Appendix 9.1 Email Consultation with OIC Environmental Health

This Appendix provides a record of the agreement of different aspects of the assessment. Excerpts from email strings are provided to make the record more concise and reduce duplication.

From: Simon Waddell <simon.waddell@itpenergised.com>
Sent: 14 May 2020 15:03
To: Paul Turner <Paul.turner@orkney.gov.uk>
Cc: David Hannon <David.Hannon@orkney.gov.uk>; Roy Ferguson <Roy.Ferguson@itpenergised.com>
Subject: Hoy wind farm - further consultation

Figure 1 - NMP1 – Little Sews – Representative of Lyness

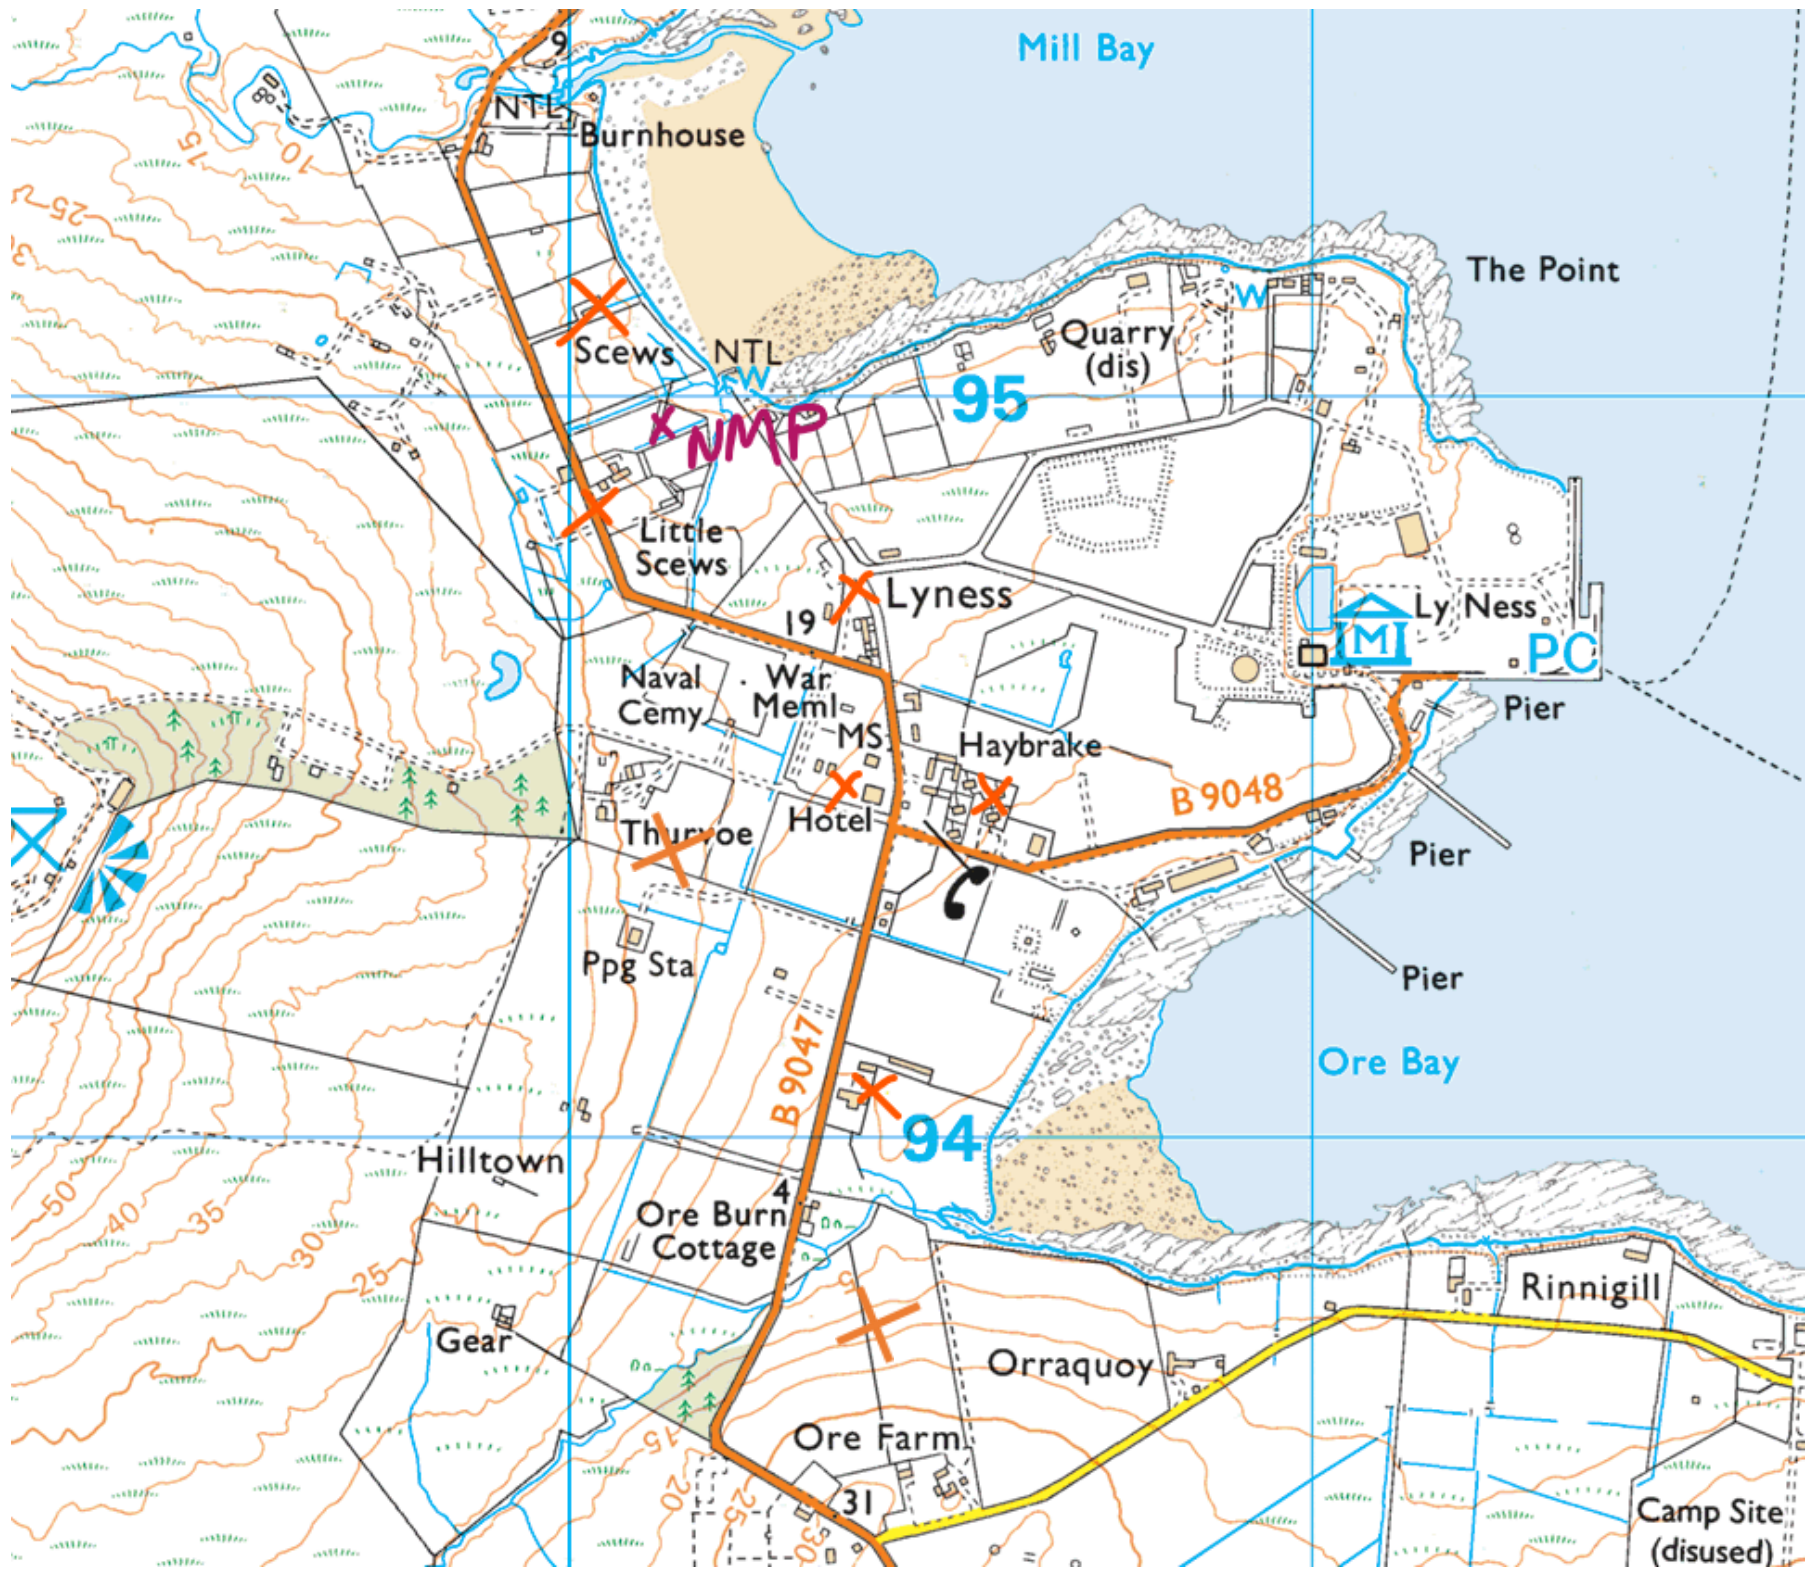
I provide below screenshots showing the monitoring locations (in purple mark up) and the receptor locations for which we propose to use the NMPs as proxies to characterise the noise environment (orange mark up).

Please confirm whether you agree with the above?

[Paul Turner] I have no objection to the allocation of the Noise Sensitive Receptors (NSRs) to Noise Monitoring Positions (NMPs) as per your figures.

NMP3 – Upper Seatter – Representative of Upper Seatter, Stoneyquoy, Muirs, North Ness and Little Ayre.

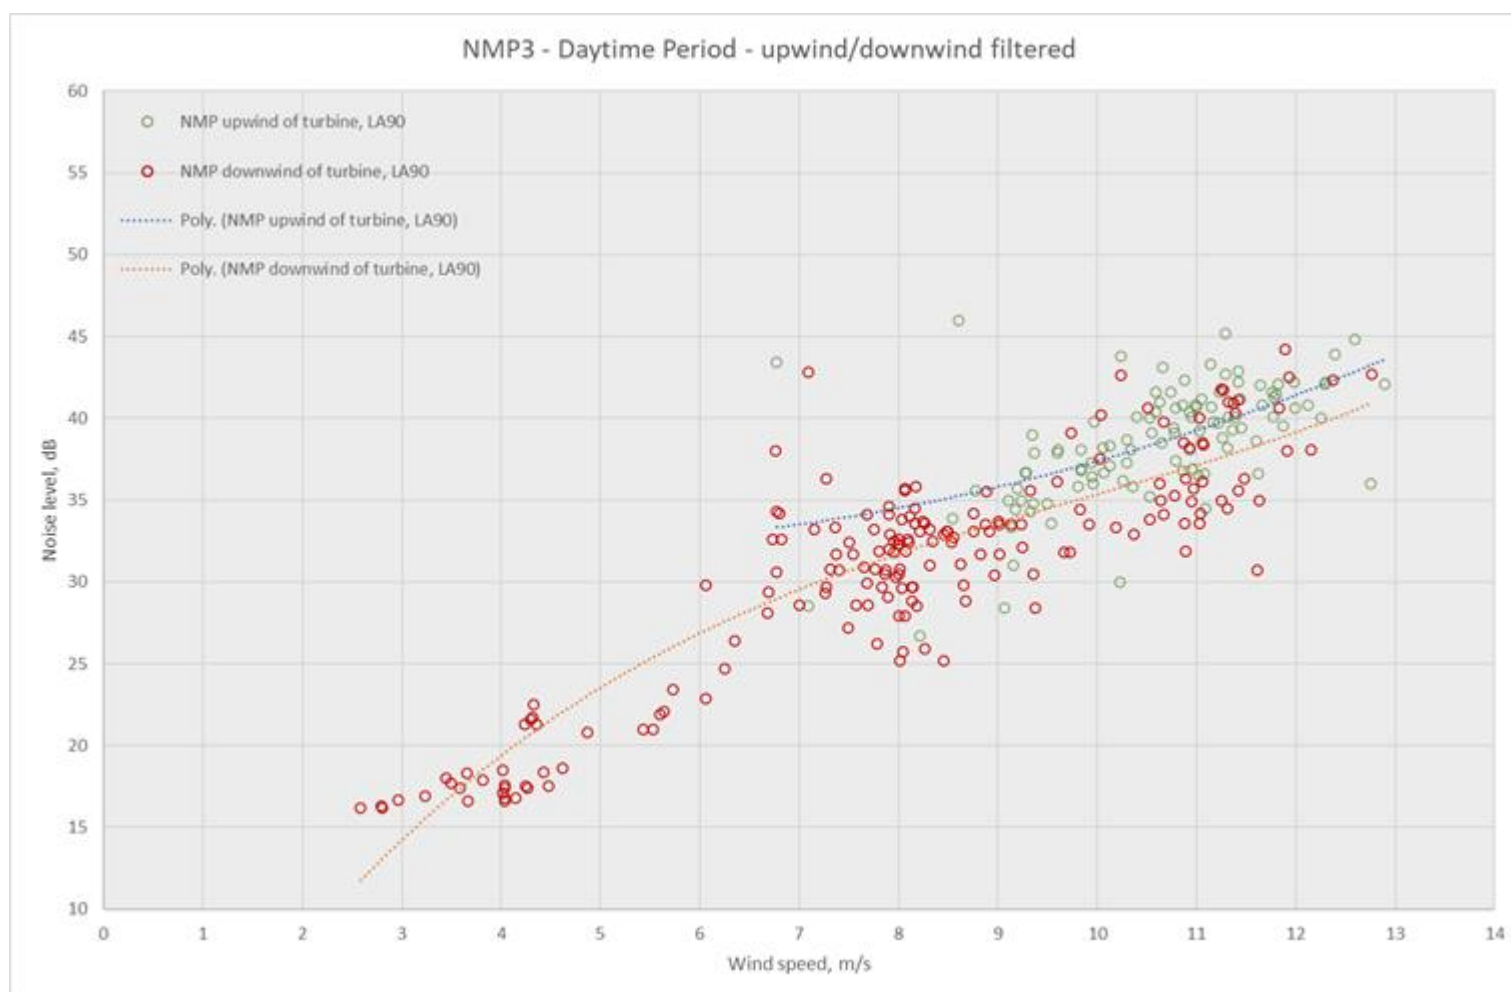
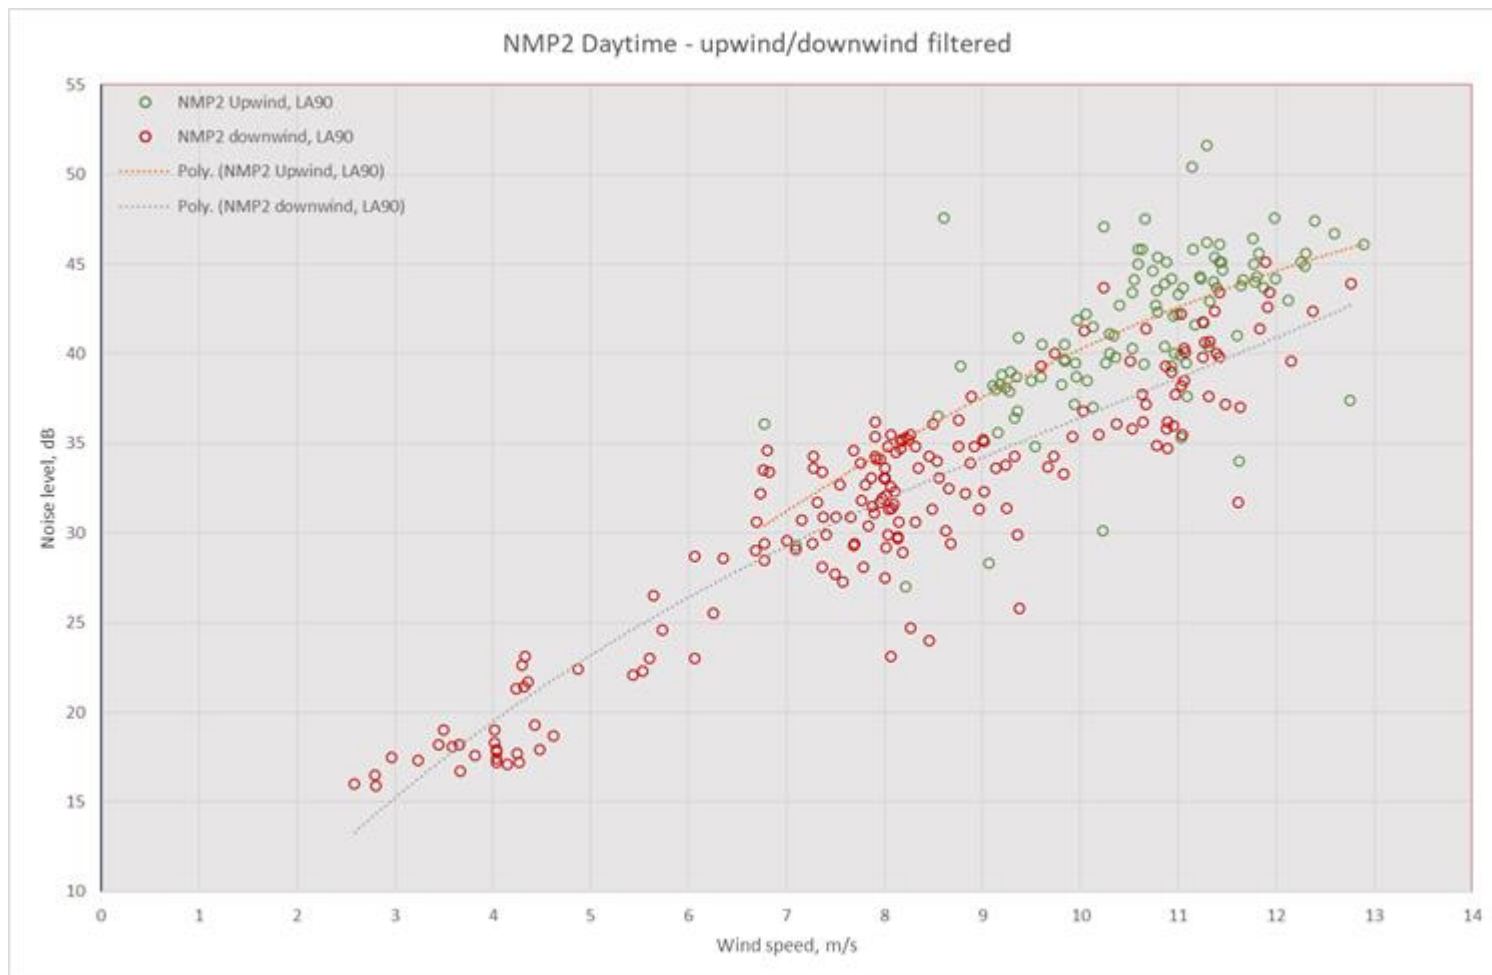
There are existing turbines potentially within audible range of NMP2 and NMP3. To examine the effect of turbine noise on measured noise levels, we have filtered the monitoring data to exclude rainfall, and split the measured data between upwind and down-wind conditions (broadly a north-south split at both monitoring locations). The filtered data is provided for the daytime period both NMPs in the following charts (note – insufficient data for a comparison during the night-time period):

The red datasets are when the NMP is downwind of the turbine(s), and the green datasets are when the NMP is upwind of the turbines. The charts show that there is little difference between upwind and downwind conditions, and marginally higher noise levels occur when the NMP is upwind of the turbines.

We therefore suggest that the influence of the turbines on the baseline noise environment at these locations is negligible, and that no further corrections are required to baseline data to derive noise limits.

Please can you confirm whether you agree?

[Paul Turner] I am currently NOT able to agree with this statement:-

On face value the charts show a clear difference of ca. 2dB (NMP3) and ca.4dB (NMP2) between upwind and downwind conditions, I do not agree that these differences are negligible – in this respect larger scale/clearer charts and inclusion of the Polynomial equations would have helped.

Unless I am misinterpreting something, the charts appear to show that when the NMP is Upwind of the Turbine(s) the noise levels are higher, and Lower noise levels when downwind. I would have thought the opposite would be the case?
